## MEMORANDUM

TO: ISC team  
FROM: Daniel Sigg, Koji Arai  
SUBJECT: EOM/AOM Diver Modifications  
Refer to: LIGO-E1500353-v3

This modifications apply to [D0900761-B](#), [D0900847-B](#), [D0900848-C](#) and [D1000216-B](#) to bring them to revisions C, C, D and C, respectively.

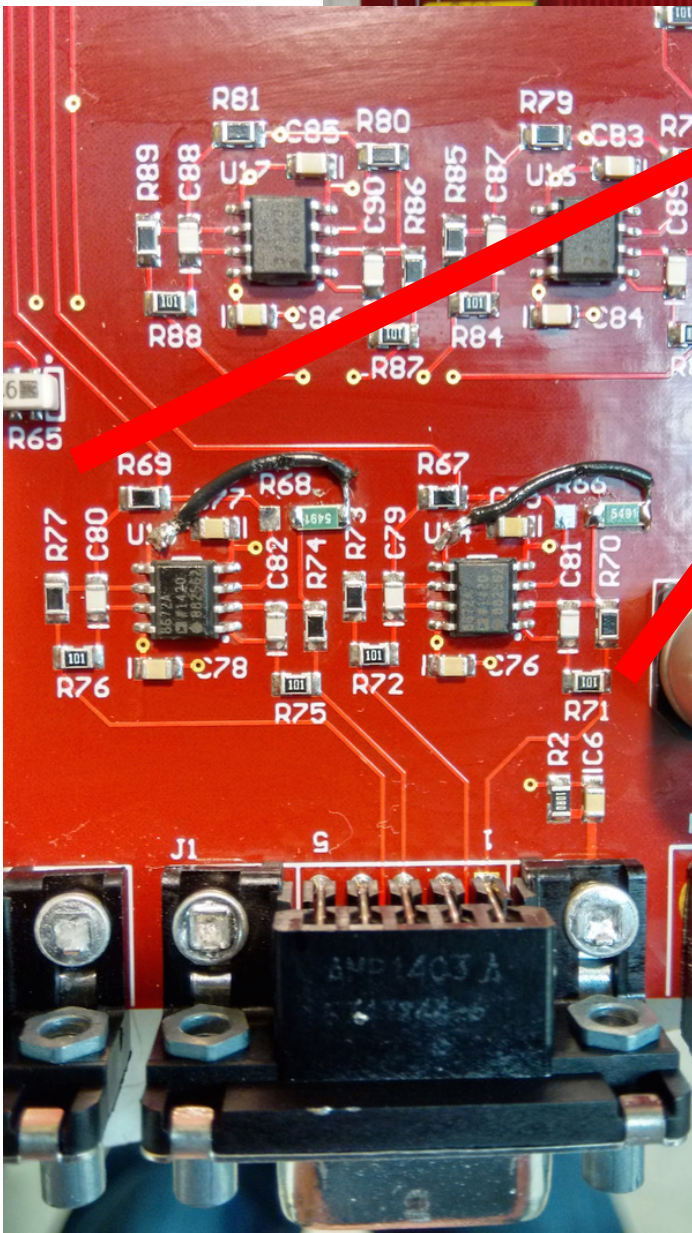
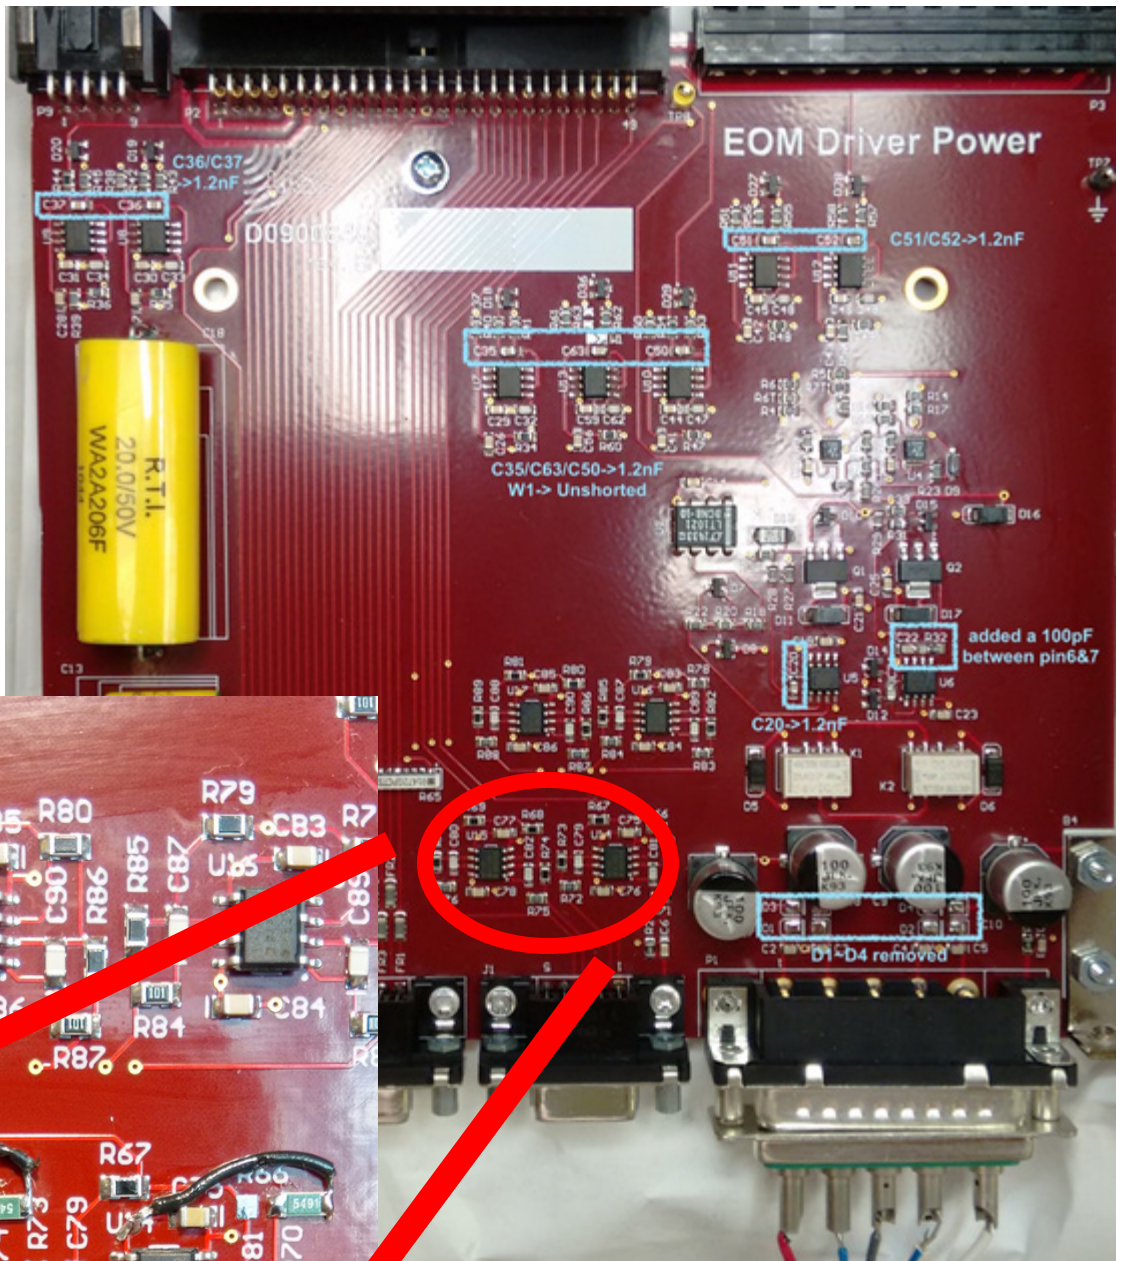
Remove the protection diodes which are no longer needed with the use of the power sequencing relays

D1, D2, D3, D4 → remove

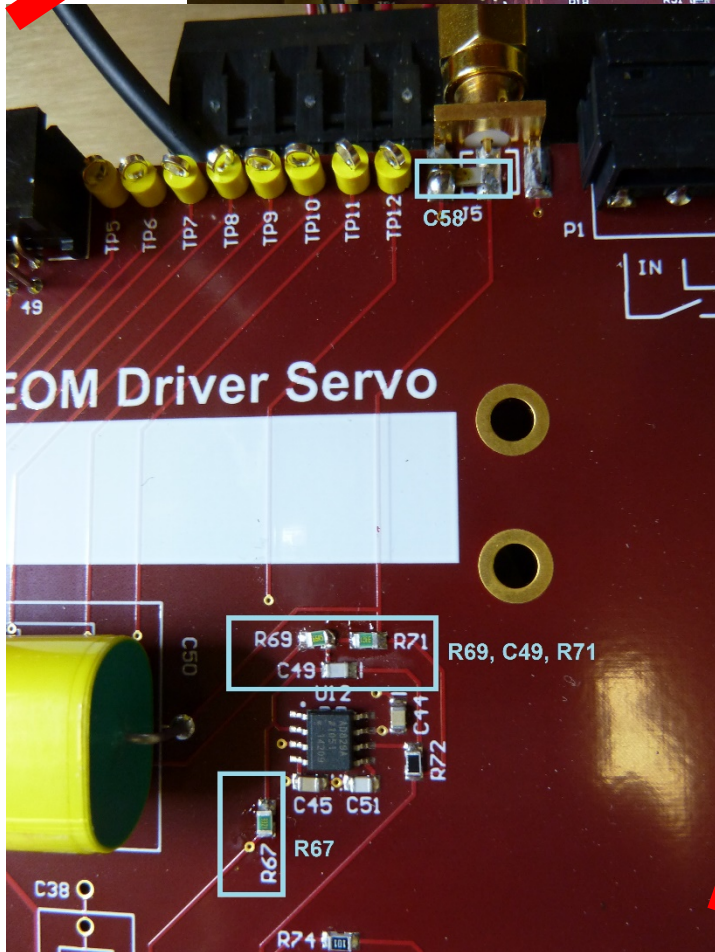
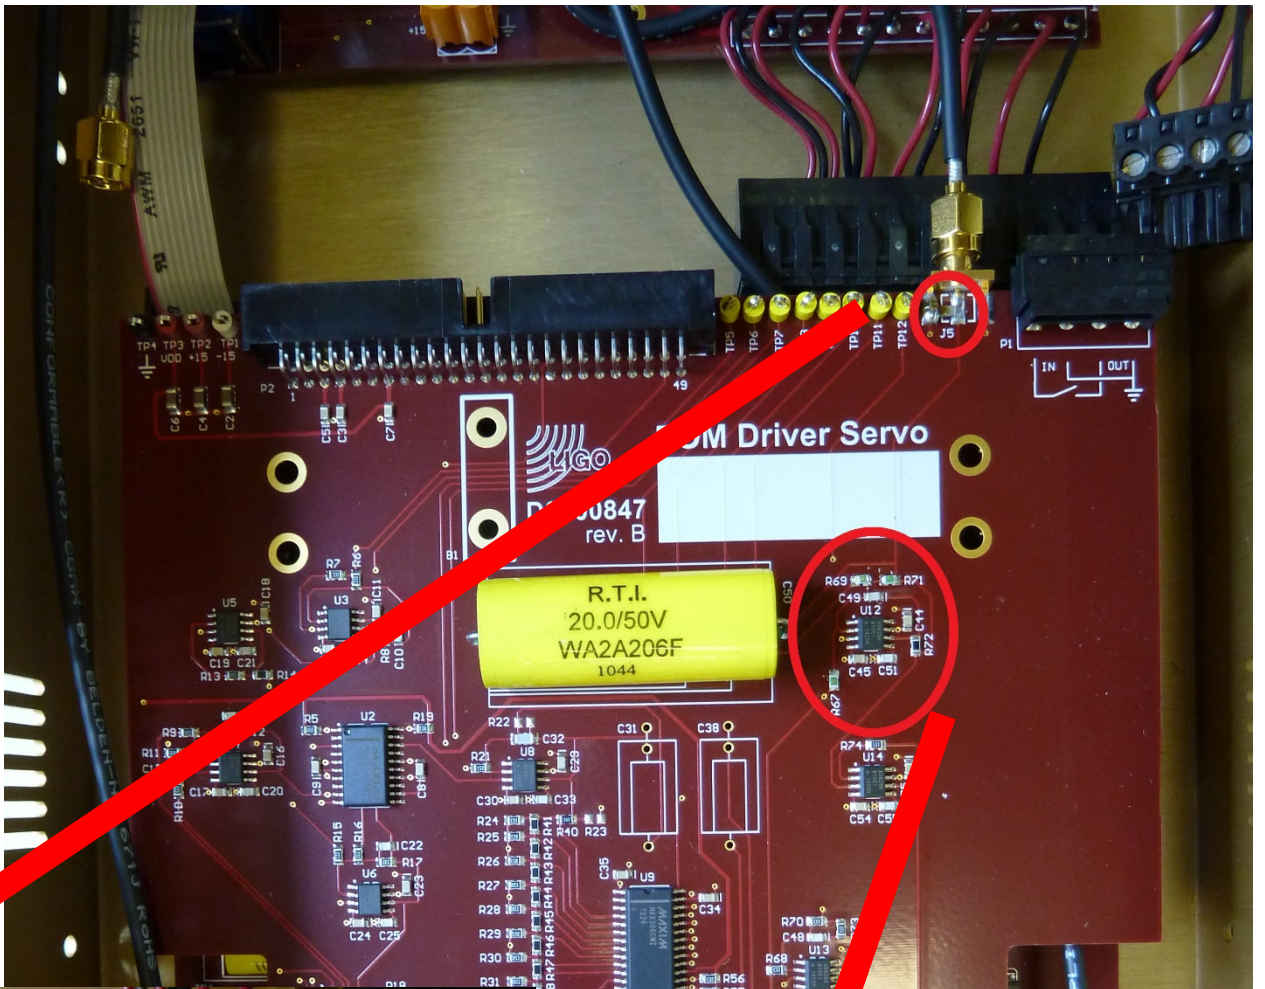
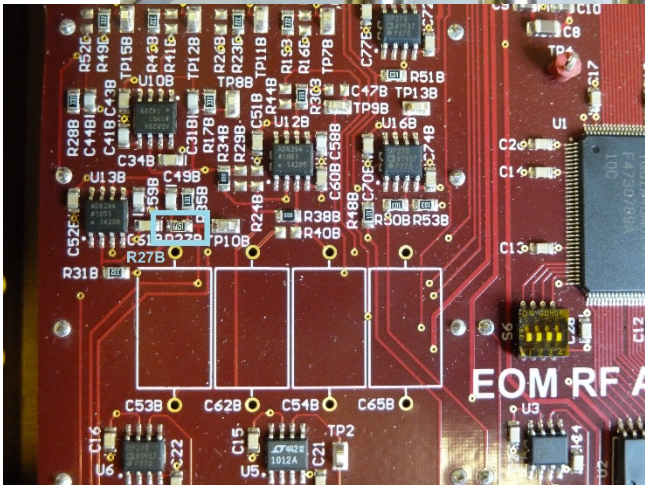
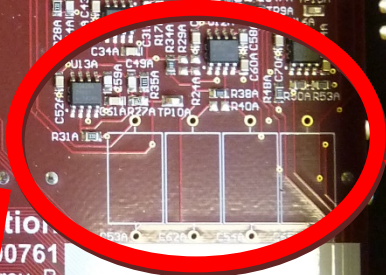
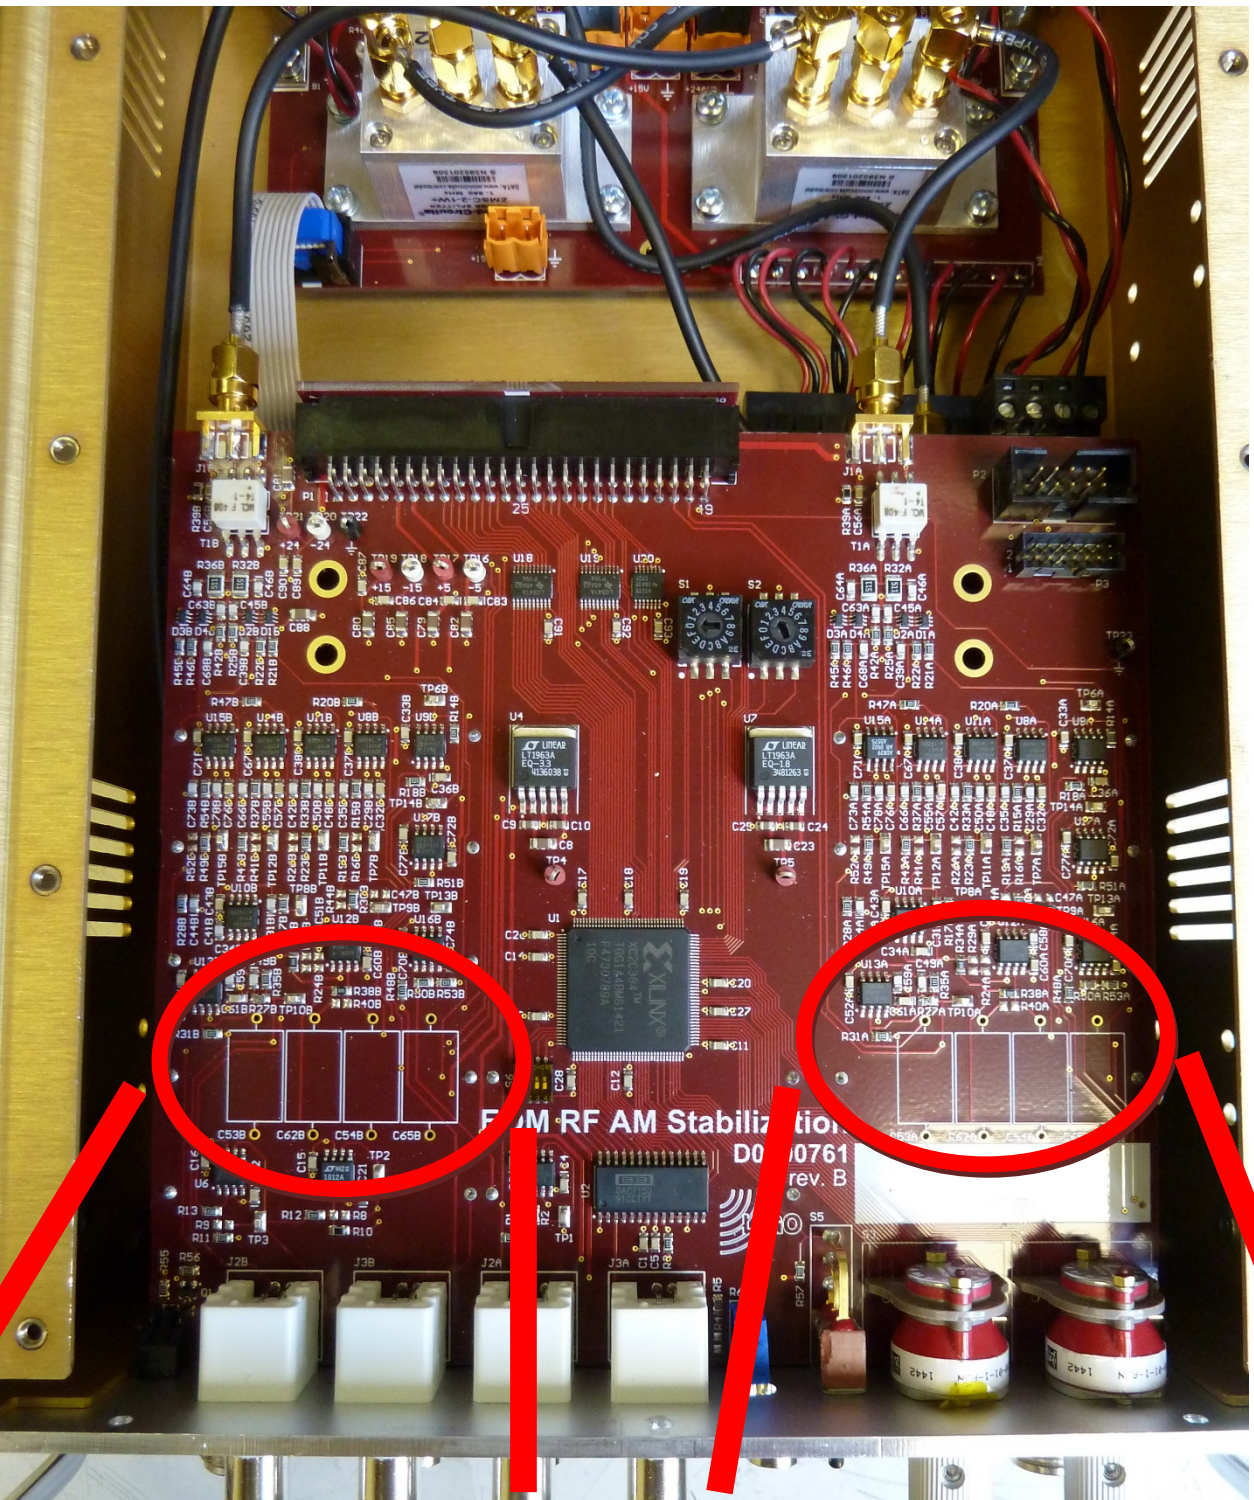
Check 1: Test the tabs of Q3 to Q9 on the power board for shorts with the rear panel.  
(Powering up the chassis with a short will damage the transistor.)

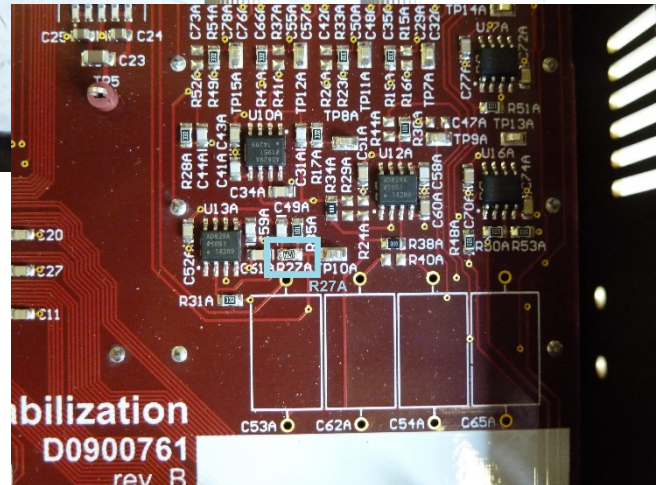
Check 2: Make sure the backplane board is inserted center into the rear connectors.  
(It is possible to offset the backplane by one row and damage Q1 or Q2 on the power board.)
